## **PLAN REVIEW SHEET**

2016-120

Pulte Home Corp.

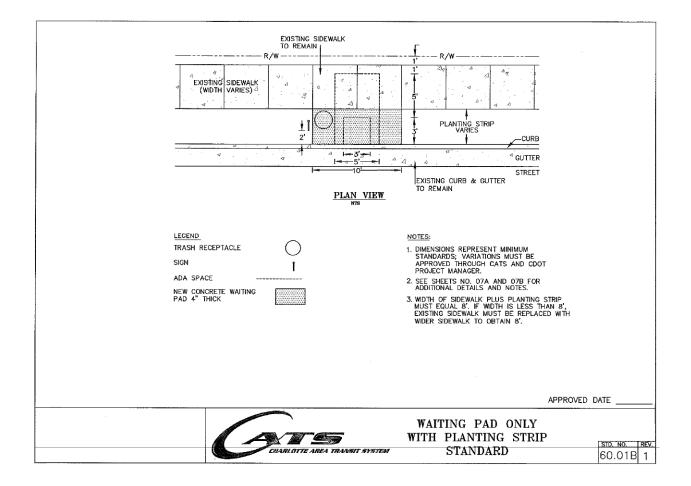
This site is located on an existing bus route. The Petitioner is requested to provide and construct a new waiting pad for a relocated bus stop on Steele Creek Road.

The existing bus stop on Steele Creek Road south of Brown-Grier Road is recommended for relocation north of Brown-Grier Road to eliminate a potential conflict with the right-turn lane from Steele Creek Road.

Below is an image of the standard detail (60.01B) for the requested bus stop pad. Permanent easement is requested, where dimensions exceed existing or proposed right-of-way limits.
